DEVELOPMENT REVIEW BOARD

Planning Dept. - Major Case Comments

Project Number: PR-2018-001346

Application Number: SI-2022-00184
Project Name: Whataburger at San Pedro Drive NE and Alameda Boulevard NE

A2 EAST ELEVATION - MAY 21st @ 4:00 P.M.
SCALE 1/4" = 1'-0"

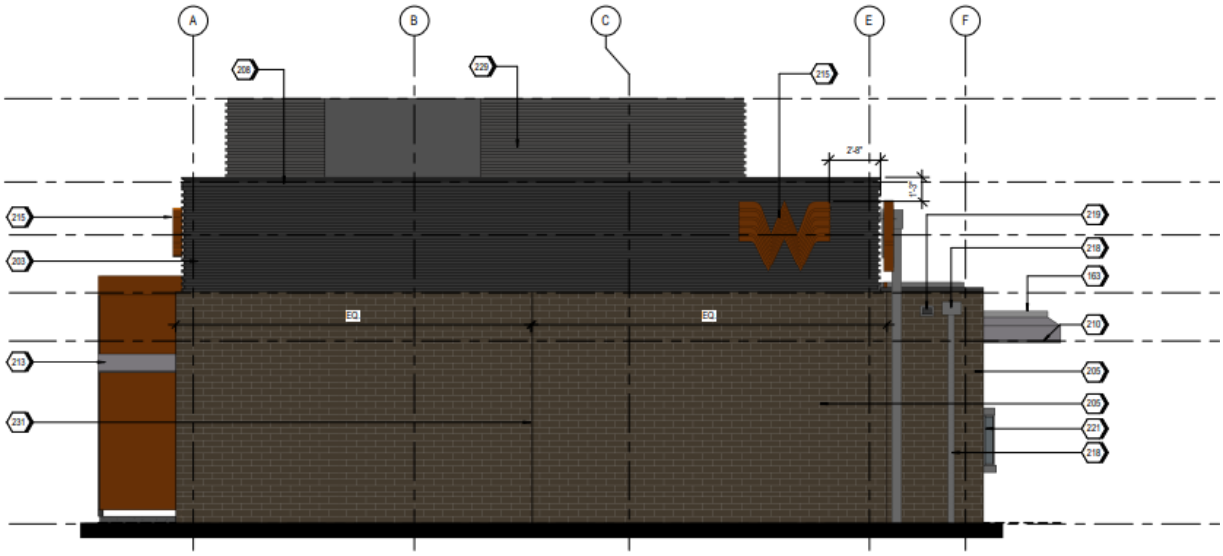
- The Climatic and Geographic Analysis is thorough and informative. Could there be any consideration to reorient the building to have the dining room windows facing the east instead of the west for a preferred solar orientation and better building performance? The orientation of the dining room to the east would provide a preferable occupant experience in terms of lighting and capturing views of the Sandia mountains.
